**MAPLE SWAMP WETLAND MITIGATION SITE
FINAL ANNUAL MONITORING REPORT – YEAR 0**

NCDEQ Contract No. 200206-01

NCDMS ID No. 100190

Subject: SAW-2021-00345 / Maple Swamp Wetland Mitigation Site / MYO DMS
Comments/ Tar-Pam 03020102; Edgecombe County, NC

AS-BUILT
PLANTING

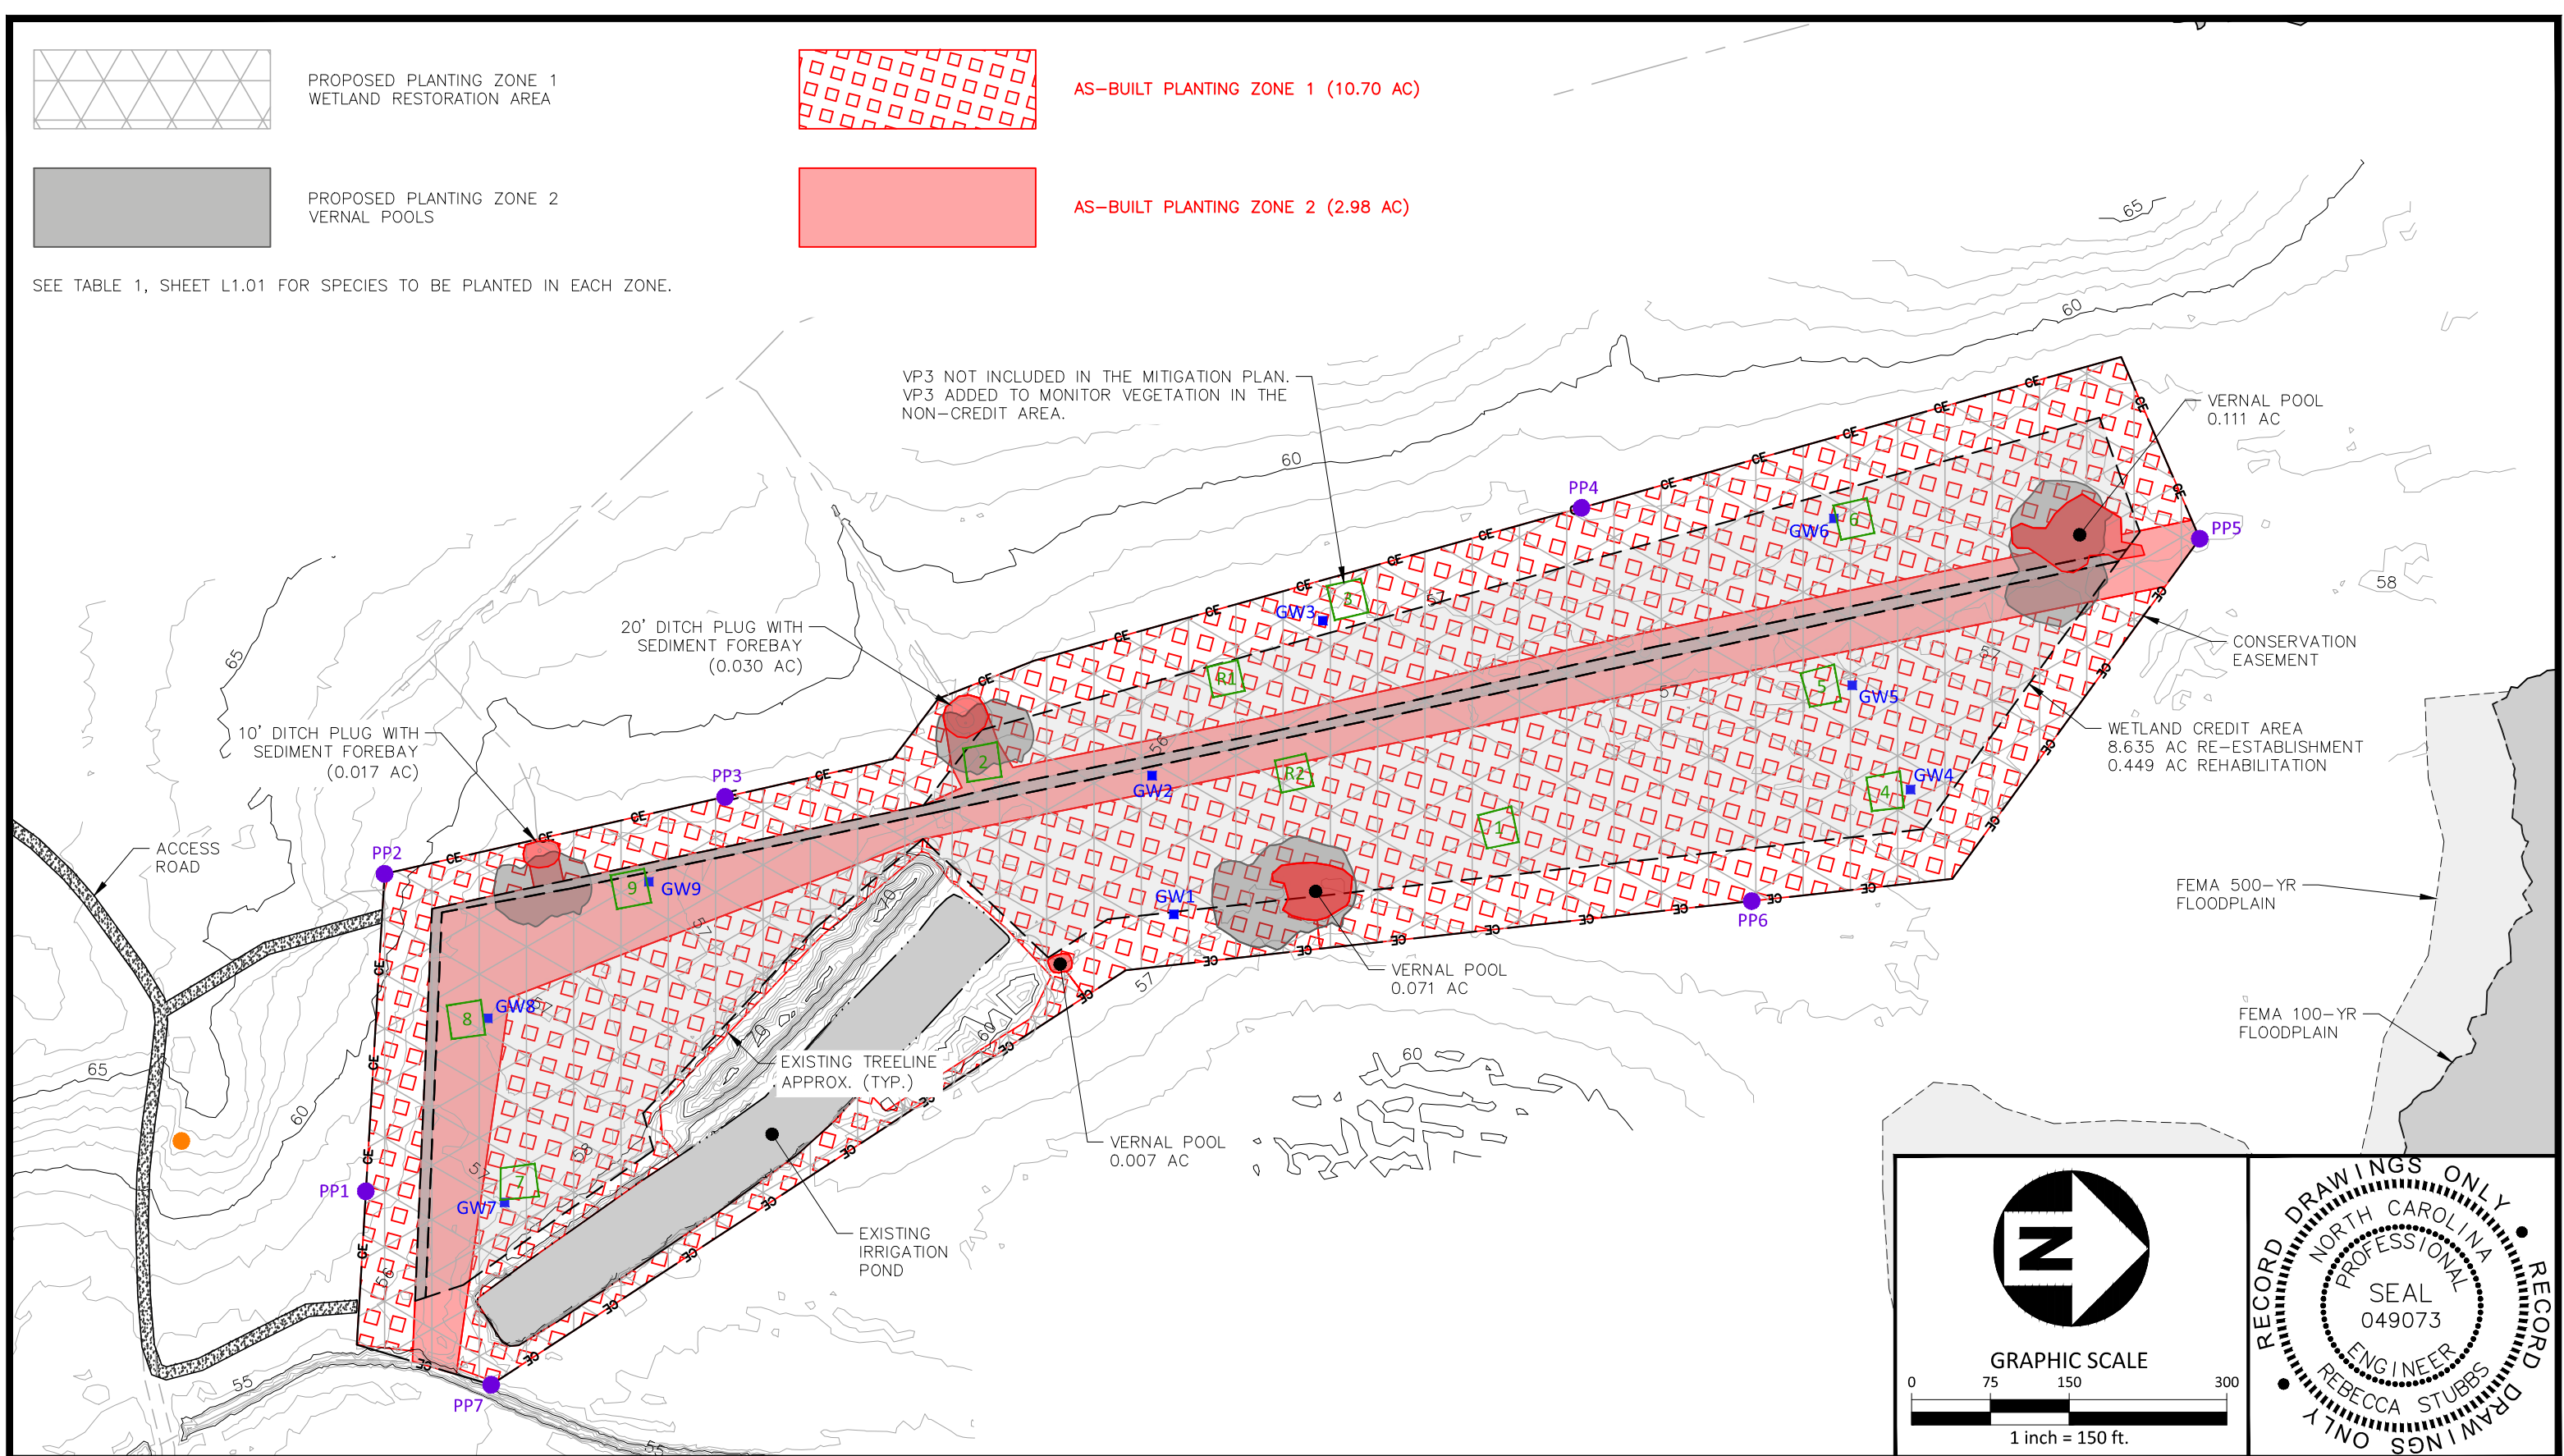
10. Page 2. Planted stems table. The narrative describes different species or zones, but the table does not differentiate which ones were limited to the vernal areas. See comment below regarding planting table from As-built.

20. Table 1. In As-built drawings is helpful. Suggest this table should replace Table 1 and Table 4 in your report.

Per the below comment, Table 4 in the report has been updated to match the as-built planting table in the record drawings

Table 4 in the report has been updated to match the table shows in the record drawings.
